PCN	Product Change Notification	De-21-05-0467	
Product	ERmet ZD	Date of Publication:	
		10.05.2021

Title: Modification of the female housing

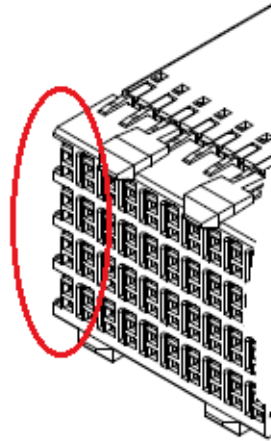
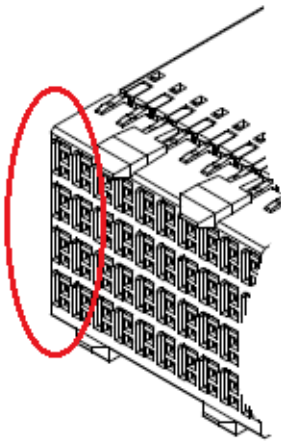
To optimize the manufacturing and handling process of the female ERmet ZD connectors the geometry of the connector housing has changed. The bars at the mating face have been removed. This change has no influence on the mating behavior.

old geometry

new geometry
